<b>Office Action Summary</b>	<b>Application No.</b> 10/562,399	<b>Applicant(s)</b> KROGEDAL, ARNULF
	<b>Examiner</b> MATTHEW A. JOHNSON	<b>Art Unit</b> 3656

## DETAILED ACTION

FIG. 2

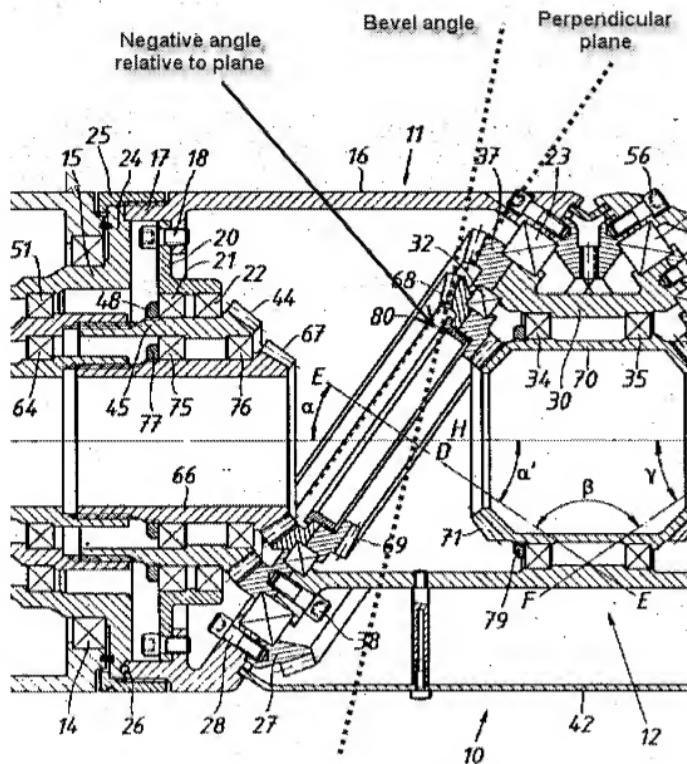
- wherein a generatrix of the conical surface of least one of said gear members (one of gears 68, 37, 74) has a negative bevel angle (as shown in Fig. 2, gears 68, 37 and 74 are concave bevel gears having internally formed teeth that are angled inwardly relative to a plane perpendicular to their rotation axis) relative to a plane perpendicular to an axis of rotation of said gear member (Fig. 2).

Re claim 2: Dahlquist discloses at least one of said gear members (one of gears 67, 27, 55, 60) has a positive bevel angle relative to a plane perpendicular to the rotation axis (Fig. 2) and at least one other said gear member (68, 37, 74) has a concave bevel gear with a negative bevel angle (as shown in Fig. 2, gears 68, 37 and 74 are concave bevel gears having internally formed teeth that are angled inwardly relative to a plane perpendicular to their rotation axis).

11. Applicant's arguments filed 9/22/2010 have been fully considered but they are not persuasive.
12. Applicant argues that Dahlquist does not disclose at least one gear member having a negative bevel angle relative to a plane perpendicular to an axis of rotation of said gear member. Applicant relies on the prior art figure 6b of the instant application, which Applicant claims came from the Dahlquist reference, to support this position. However, Figure 6b labeled prior art by the Applicant, does not match any of the Figures of Dahlquist, and it is unclear where the drawing came from. That which is depicted in prior art Figure 6b is not an accurate illustration of Dahlquist's device. The rejection is based on the Figures actually disclosed by Dahlquist, and not Applicant's representation of the Figures. As clearly shown in annotated Figure 2 reproduced below, Dahlquist discloses a concave bevel gear (37 or 68 or 74) having internal teeth that are angled inward towards the axis of rotation, relative to a plane that is perpendicular to the axis of rotation. Additionally, describing an angle as negative or positive depends on the perspective used to measure the angle. A positive angle from one side of the plane could also be considered to be a negative angle from the other side of the plane.
